0318-08 37 DEG JIC TUBE NUT
ALL DIMENSIONS ARE REFERENCE VALUES IN INCHES MEASURED ON THE 3D MODEL - NO TOLERANCES.
VALUES CARRY THE DECIMALS OF THE SOURCE DATA (E.G. HEX 0.88 = 7/8 IN A 2-PLACE CATALOG).
THREADS NOT SHOWN.
3D MODEL: 0318_MASTER, CONFIGURATION 0318-08. SCALE 3:1

0403-08-08 UNPL BRAZE TUBE UNION (BRAZE SOCKET X MALE JIC)
ALL DIMENSIONS ARE REFERENCE VALUES IN INCHES MEASURED ON THE 3D MODEL - NO TOLERANCES.
VALUES CARRY THE DECIMALS OF THE SOURCE DATA (E.G. HEX 0.68 = 7/8 IN A 2-PLACE CATALOG).
THREADS NOT SHOWN.
3D MODEL: 0403_MASTER, CONFIGURATION 0403-08-08 UNPL. SCALE 3:1

1404-08-08 MALE PIPE X FEMALE NPSM SWIVEL ADAPTER UNION
ALL DIMENSIONS ARE REFERENCE VALUES IN INCHES MEASURED ON THE 3D MODEL - NO TOLERANCES.
VALUES CARRY THE DECIMALS OF THE SOURCE DATA (E.G. HEX 0.88 = 7/8 IN A 2-PLACE CATALOG).
THREADS NOT SHOWN.
3D MODEL: 1404_MASTER. CONFIGURATION: 1404-08-08. SCALE 2:1

1501-08-08-FG 90 DEG MALE PIPE X FEMALE NPSM SWIVEL ELBOW
ALL DIMENSIONS ARE REFERENCE VALUES IN INCHES MEASURED ON THE 3D MODEL - NO TOLERANCES.
VALUES CARRY THE DECIMALS OF THE SOURCE DATA (E.G. HEX 0.88 = 7/8 IN A 2-PLACE CATALOG).
LEG LENGTHS: AXIS CROSSING (CENTRE) TO END FACE, AL

TITLE: 37 DEG JIC TUBE NUT

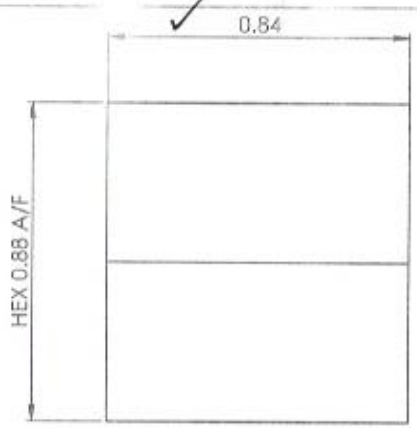
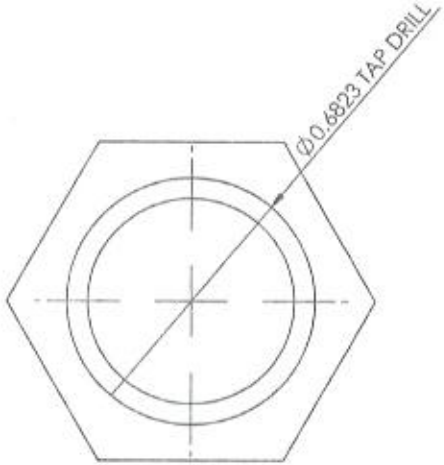
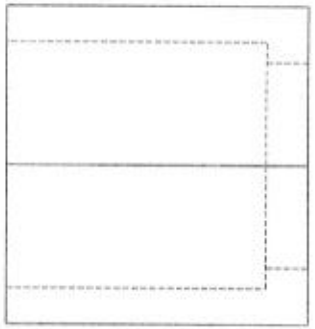
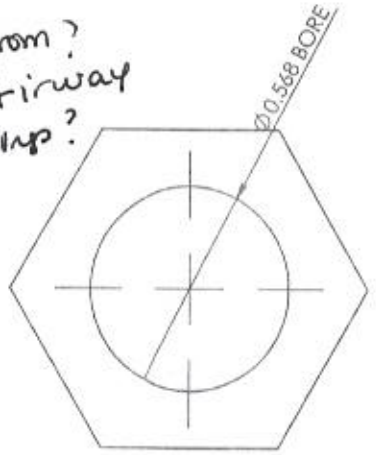
I do not see thread listed
3/4-16 B UN/UNF-2B?

Where did Bore & Tap Drill dimensions come from? Not on Airway or BI drawings?

TITLE: BRAZE TUBE UNION (BRAZE SOCKET X MALE JIC)

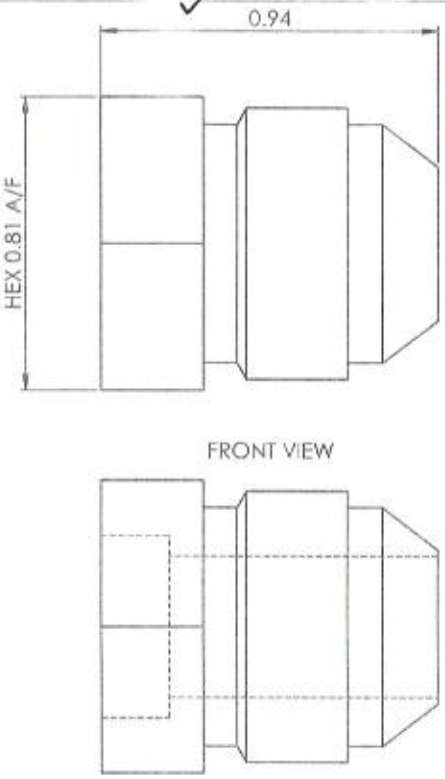
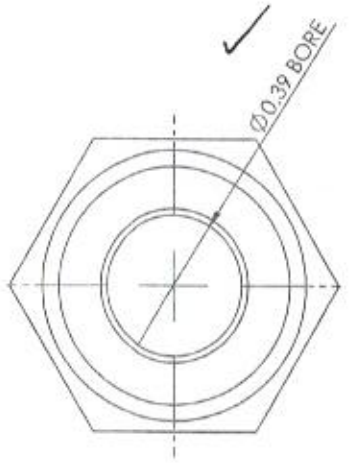
Airway has a L7 dimension
Brennan does not.

Where is thread mentioned?
degree?
cone.

D2 dimension on AW is listed as 0.497?
Double check

TITLE:
MALE PIPE X FEMALE NPSM SWIVEL ADAPTER UNION

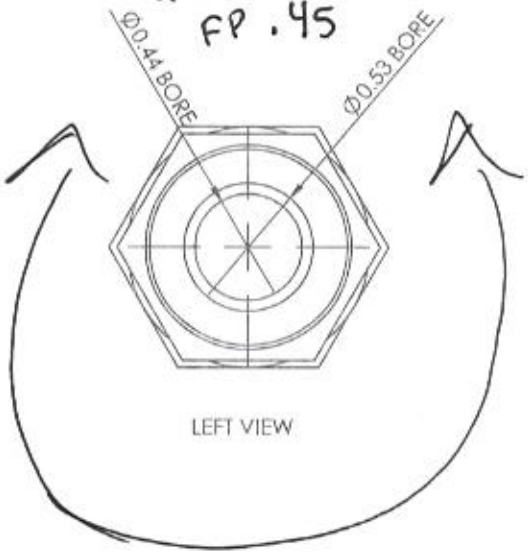
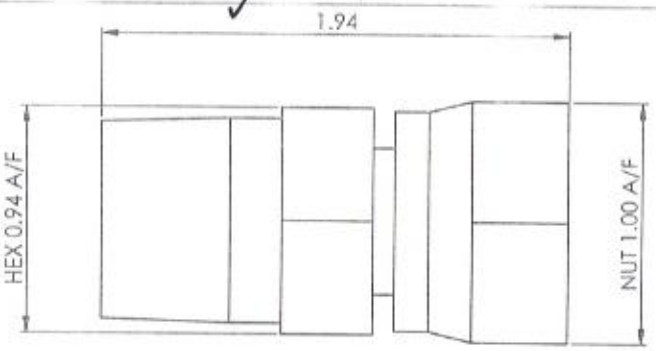
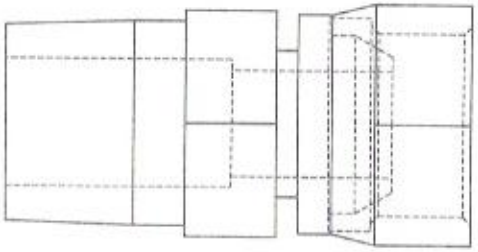
You can mention in notes unplated. Do not put in part #.

Brennan overall length is 1.89
there is a big difference.

There should bore on both sides. One for MNPT .53 & other for FP .45

Where are the threads listed?
Degree cones?

There is an L dimension missing

TITLE: 90 DEG MALE PIPE X FEMALE NPSM SWIVEL ELBOW

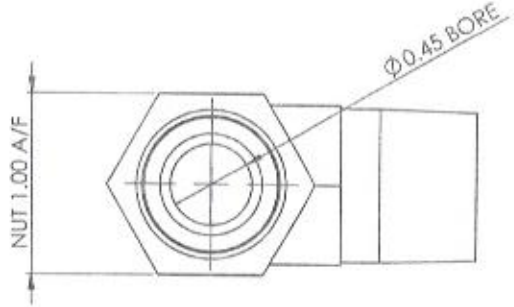
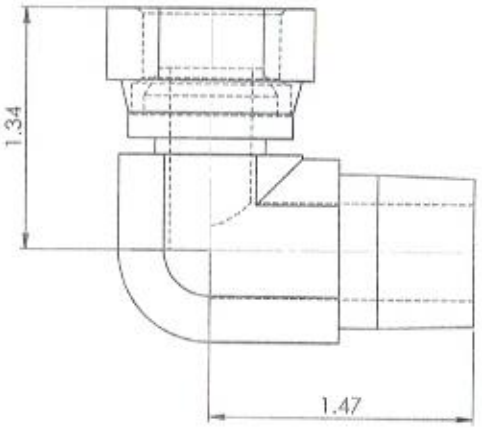
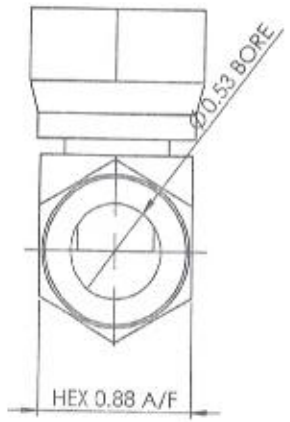
Where is M1 dimension?
Where is C1 dimension?
Threads?
Cones?

Boerman is 1.39 that is significant difference.

TITLE: FEMALE PIPE X FEMALE NPSM SWIVEL ADAPTER UNION

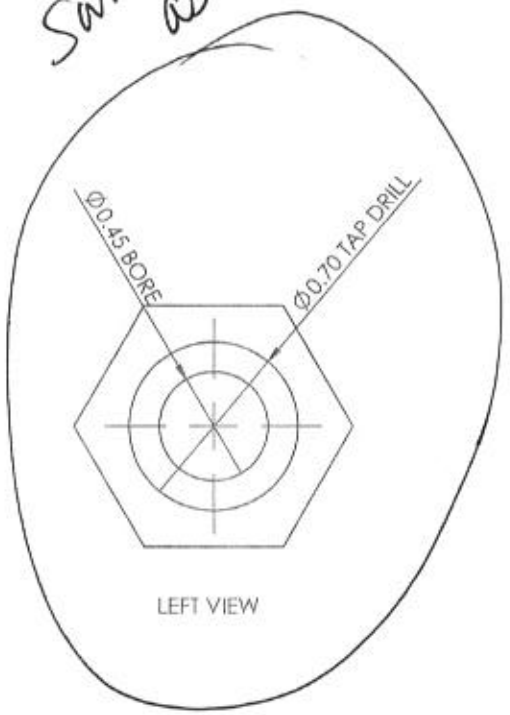
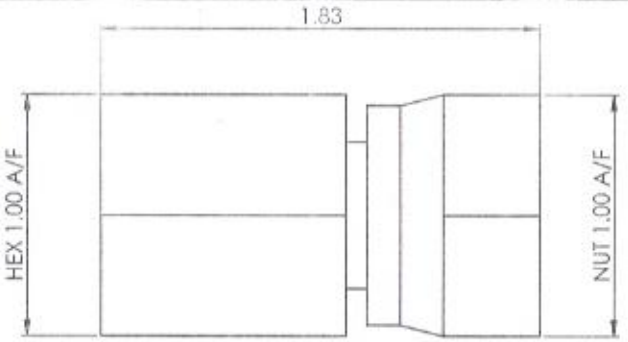
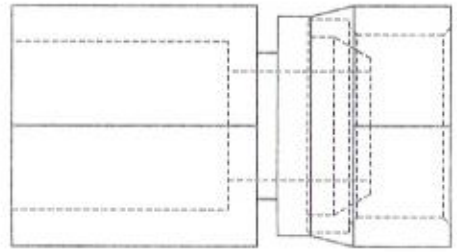
Same thing as 1404

I do not see the thread listed?
Degree?
L dimension?
